# VOLLMER ROAD (BARBARICK)

## STREET IMPROVEMENT PLAN

90% PLAN SET - NOVEMBER 2021

**VOLLMER ROAD (BARBARICK)**  
**SIGNAGE & STRIPING**

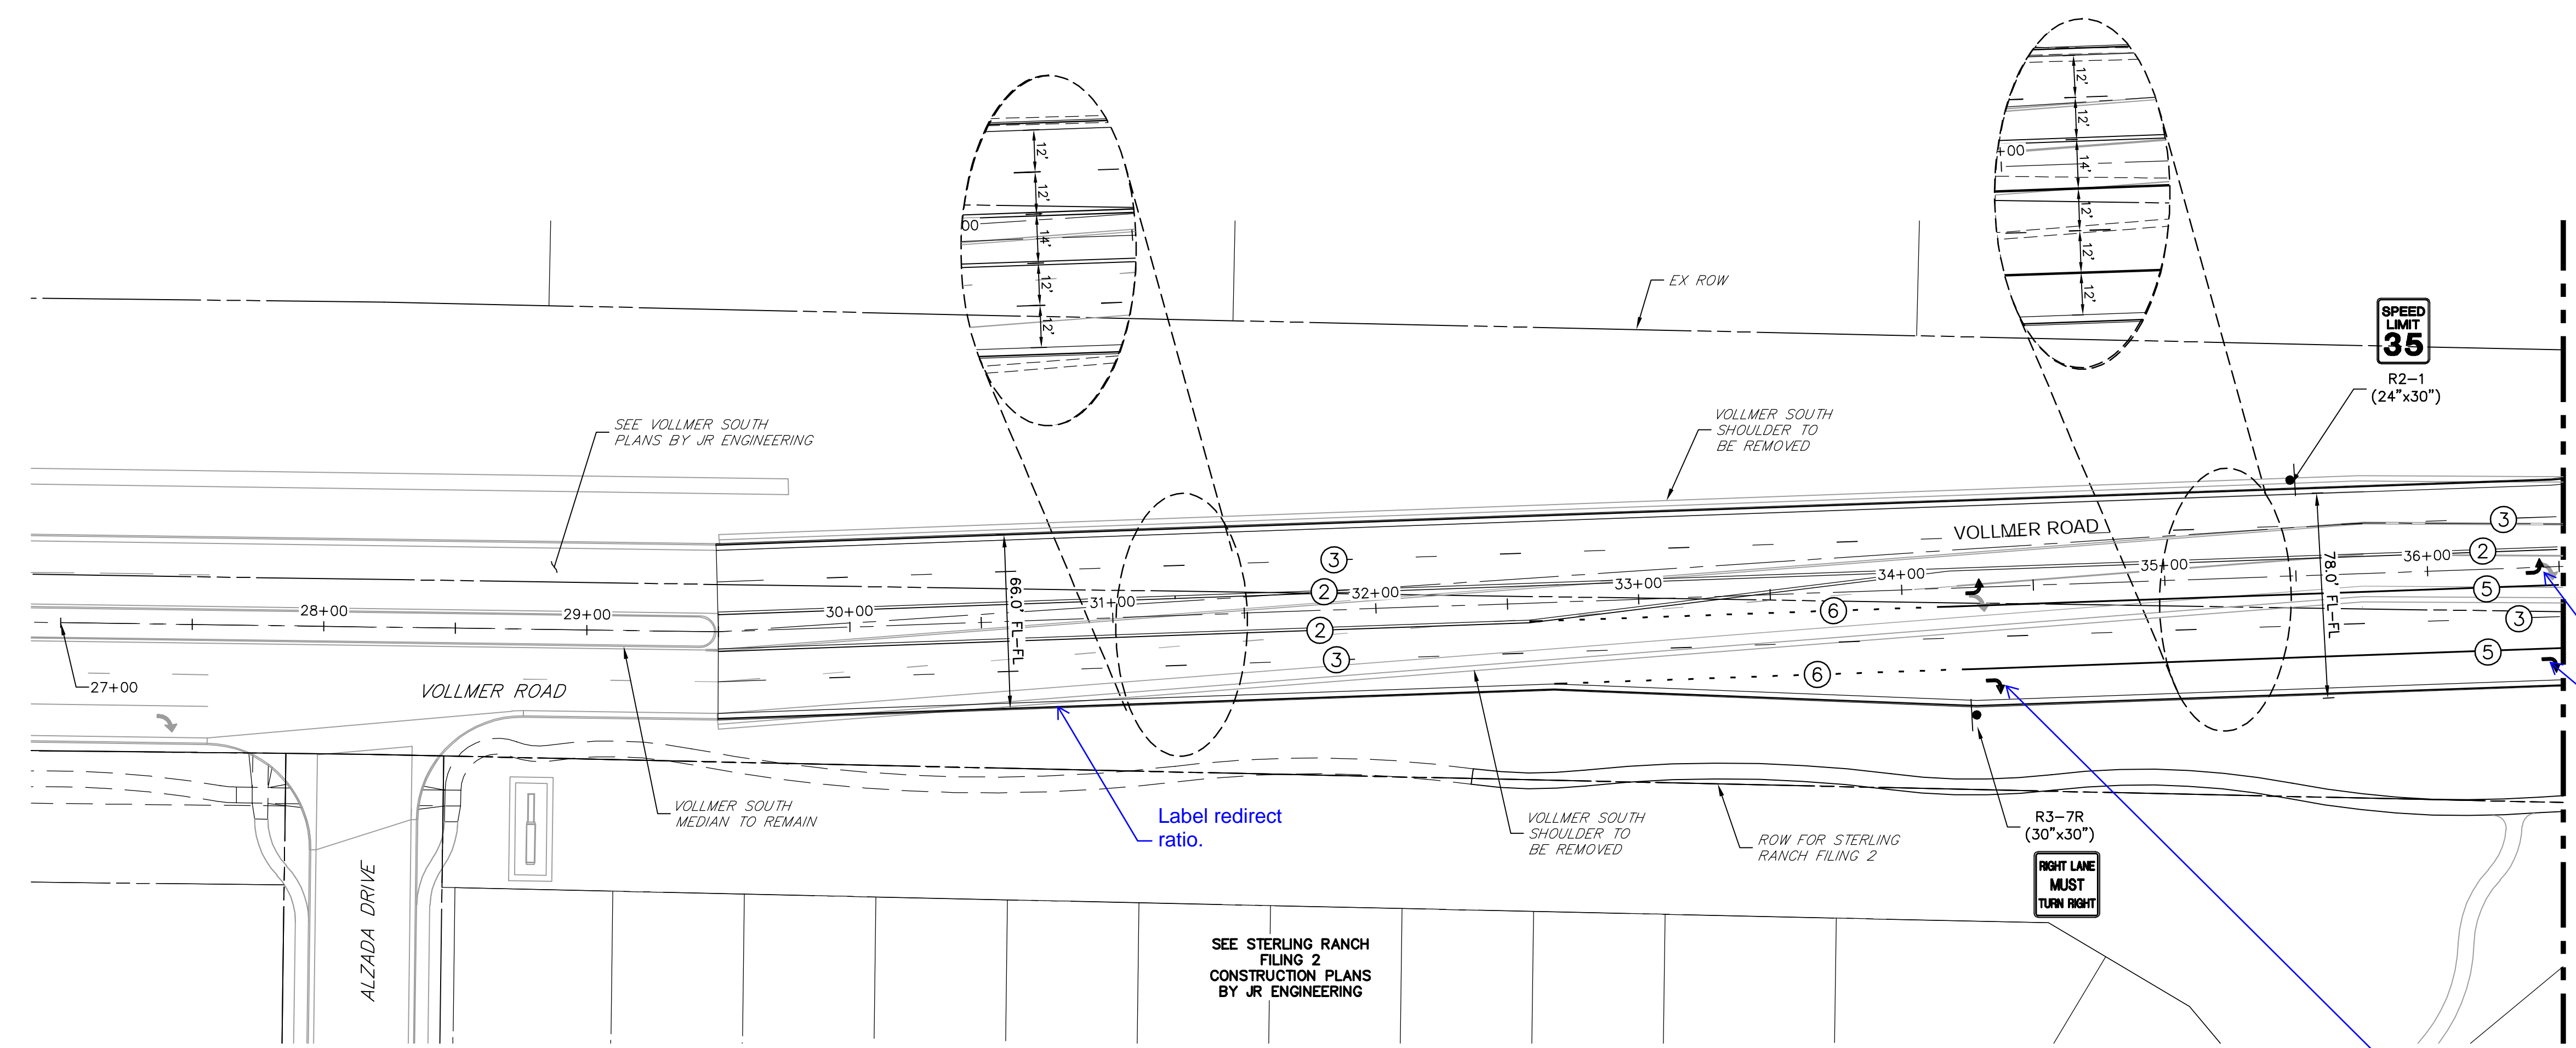
Arrows need to be 50' from intersection - See CDOT Std S-627-1 sheet 5

Label all turn arrows
